PIC12(L)F1822/PIC16(L)F1823

PIC12(L)F1822/PIC16(L)F1823 Family Silicon Errata and Data Sheet Clarification

The PIC12(L)F1822/PIC16(L)F1823 family devices that you have received conform functionally to the current Device Data Sheet (DS41413B), except for the anomalies described in this document.

FIGURE 1: INSTRUCTION CYCLE DELAY CALCULATION EXAMPLE

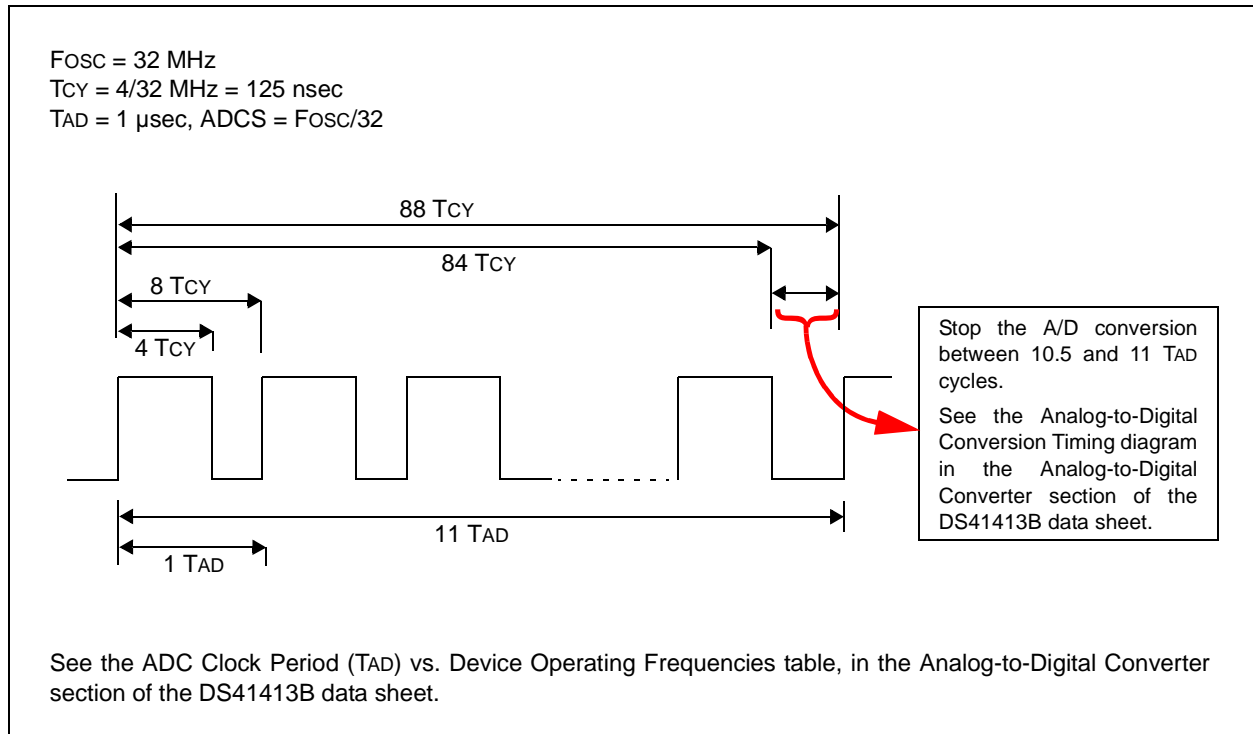
Under certain device operating conditions, the ADC conversion may not complete properly. When this occurs, the ADC Interrupt Flag (ADIF) does not get set, the GO/DONE bit does not get cleared and the conversion result does not get loaded into the ADRESH and ADRESL result registers.

Method 2: Provide a fixed delay in software to stop the A-to-D conversion manually, after all 10 bits are converted, but before the conversion would complete automatically. The conversion is stopped by clearing the GO/DONE bit in software. The GO/DONE bit must be cleared during the last ½ TAD cycle, before the conversion would have completed automatically. Refer to [Figure 1](#) for details.

In Figure 1, 88 instruction cycles (Tcy) will be required to complete the full conversion. Each TAD cycle consists of 8 Tcy periods. A fixed delay is provided to stop the A/D conversion after 86 instruction cycles and terminate the conversion at the correct time as shown in the figure above.

Note: The exact delay time will depend on the choice of Fosc and the TAD divisor (ADCS) selection. The Tcy counts shown in the timing diagram above apply to this example only. Refer to Table 3 for the required delay counts for other configurations.

```
BSF    ADCON0, GO/DONE; Start ADC conversion
      ; Provide 86
      ; instruction cycle
      ; delay here
BCF    ADCON0, GO/DONE; Terminate the
      ; conversion manually
MOVF   ADRESH, W      ; Read conversion
      ; result
```
